WR-105

RE: Marble Mountain Ranch/ Stanshaw Creek Water Right Division and North Coast Regional Water Board Inspection Reports and Notice of Violation

**DIVISION OF WATER RIGHTS
REPORT OF INSPECTION**

Photo 14 – leaks coming from one of the 3,000 gallon water tanks used for filtration.

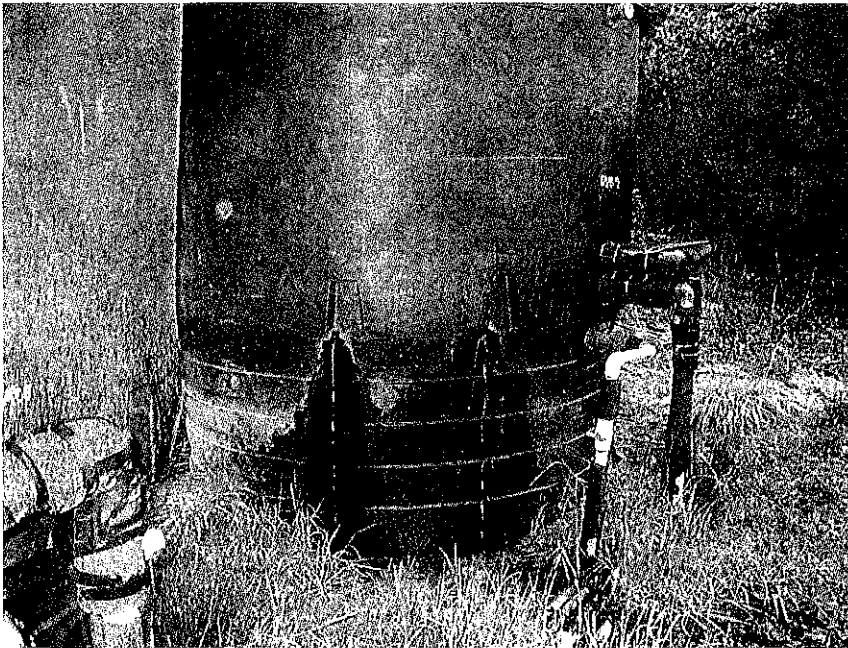
The Division finds that MMR's diversion may constitute a waste of water resources. Division staff observed a number of leaks in MMR's drinking water tanks (Photo 12 & 13). Division staff was not able to quantify the amount of water leaking from two of the three tanks used in the sand filtration process, although the leaks appear to be substantial. Quantities of water lost to leaks in the domestic water treatment plant system and not put to beneficial use constitute a waste.

3. Fix all leaks associated with the MMR water treatment system. Provide photographic evidence to the Division that all leaks were repaired and confirmation that additional leaks are not present. The Coles must provide a time schedule that identifies a date for completion of the water treatment system repairs, to be reviewed by the Division.

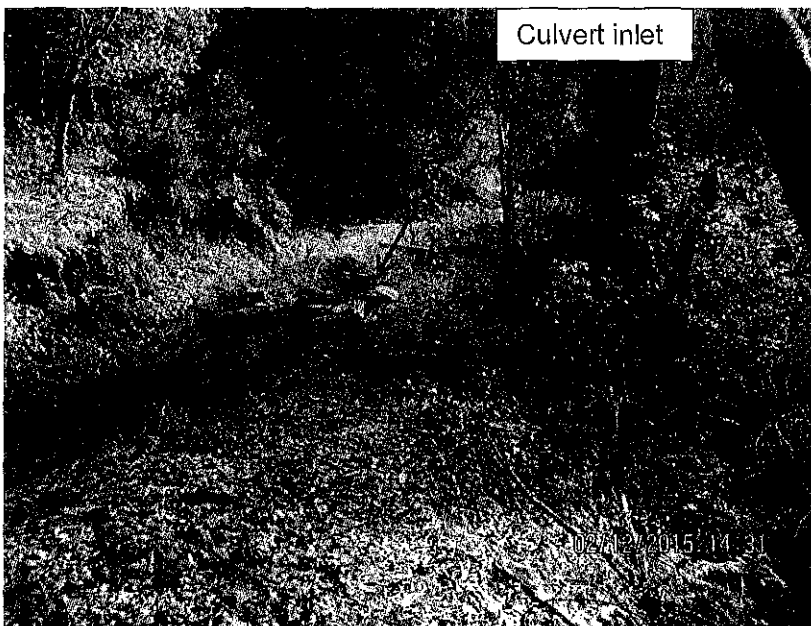
Image 9- at Point 4, shows the partial diversion of the ditch into an unnamed tributary to Stanshaw Creek through the inlet of a 12-inch culvert, before the diversion ditch is routed across the stream in a lined ditch. The culvert is shotgunned, which appears to have caused significant instream erosion in the downslope channel. The stream above the crossing is 3-4 feet wide at bankfull width; the eroded stream channel below the diversion crossing is 12-14 feet wide, and does not appear stable. At this location, I also observed muddy soils in the berm adjacent to the ditch, indicating that seepage from the ditch is saturating surrounding soils, which may lead to catastrophic failure of the ditch. (Photo 8441)

For either alternative, the ditch repair or decommissioning plan shall include specifications to restore the affected stream/unnamed tributary that crosses at inspection points 4/5, replant with native vegetation, and to protect streams from any further impacts or discharges associated with the ditch.

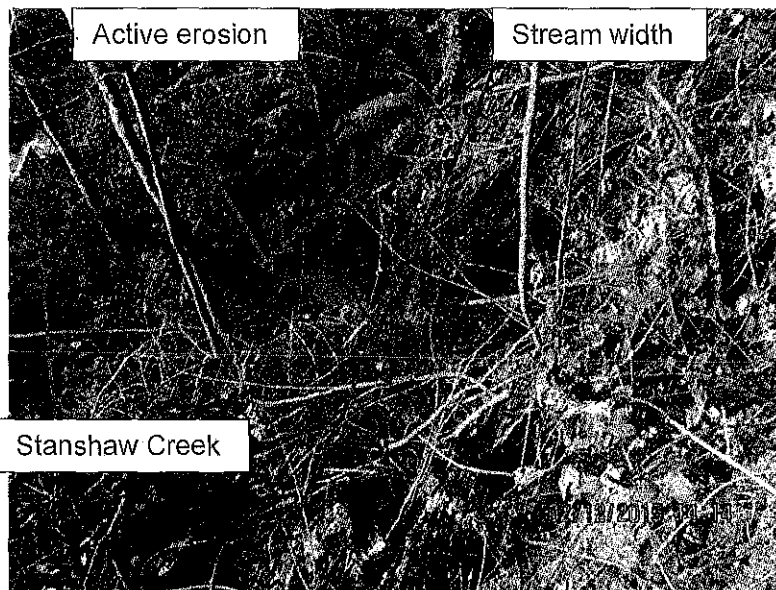
Image 11- shows the unnamed stream channel downstream of Point 5, and the erosion caused by water draining from the shotgunned culvert. Stanshaw Creek can be seen a short distance downslope. I conservatively estimate that this site has delivered 150-300yds³ of sediment and debris to Stanshaw Creek over the life of the Diversion. (Photo 8478)

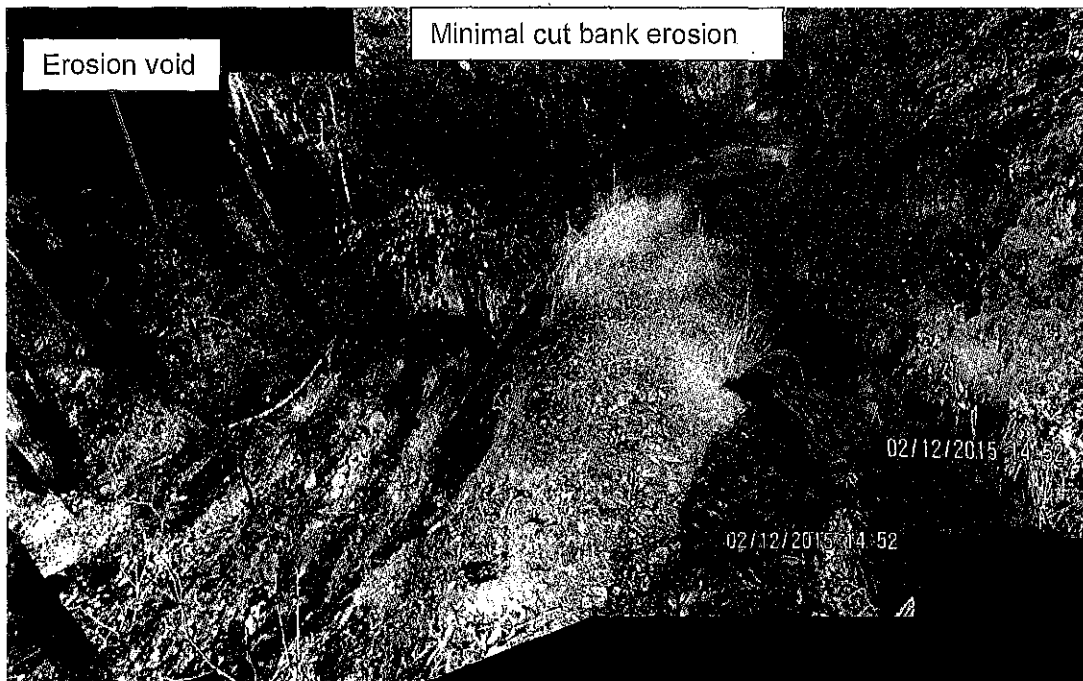
Image 16- Point 10 is an area of concern that includes an erosional channel likely formed by a berm failure and active erosion visible on the cut bank. I observed active cut bank erosion on many of the upper slopes above the diversion ditch and expect that bank slumps have and are contributing significantly to ditch failures. (Photos 8495, 8496, 8497, and 8498 composite image).

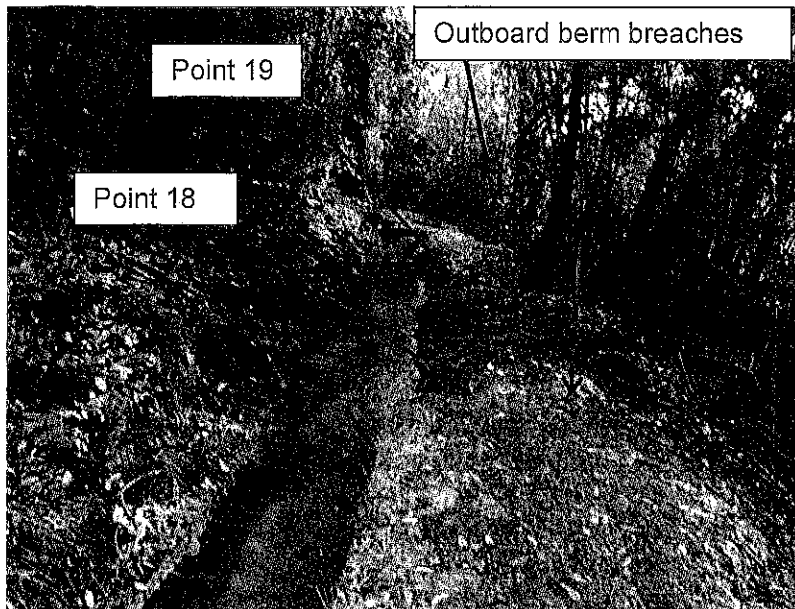
Image 25- shows two locations, points 18 and 19, where the outboard berm has apparently breached in the past, resulting in gully erosion on lower slopes. The failure at Point 19 resulted in the formation of a gully channel for a long distance down the slope, and may have contributed a significant sediment load to the Klamath River and possibly Stanshaw Creek. I did not follow the gully all the way down the slope, but did see an erosion channel from the lower road.
